# RENESAS TECHNICAL UPDATE

Product Category	Transistor		Document No.	TN-TRS-A148A/E	Rev.	1.00
Title	Transistor Change of reel material		Information Category	Technical Notification		
Applicable Product	Please refer to the following Table. 1		Lot No.	Reference Document	Nothing	
			all

**Fig1. Comparison before and after change**

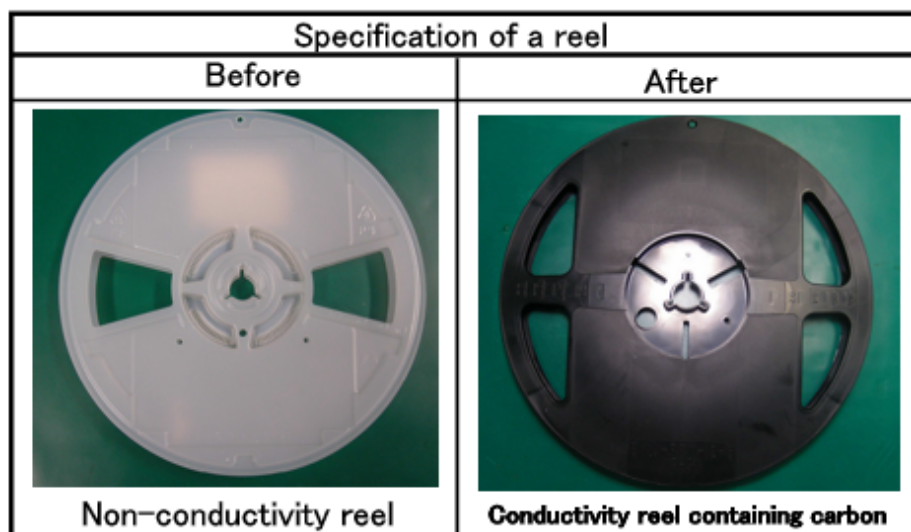
- Reason Standardization of applicable products
- Contents Please refer to the following Fig 1 and Table 1. It will use the conductivity material in the future though these are produced on the non-conductivity material for the reel now.
- Schedule We will start the changes from Jan. 2015 gradually. Delivery of new or current versions depends on stock.
- Remarks After change, there is no change of the guarantee electrical characteristic and the reliability of each product. Renesas Electronics Corp. is responsible for the product quality as usual before.
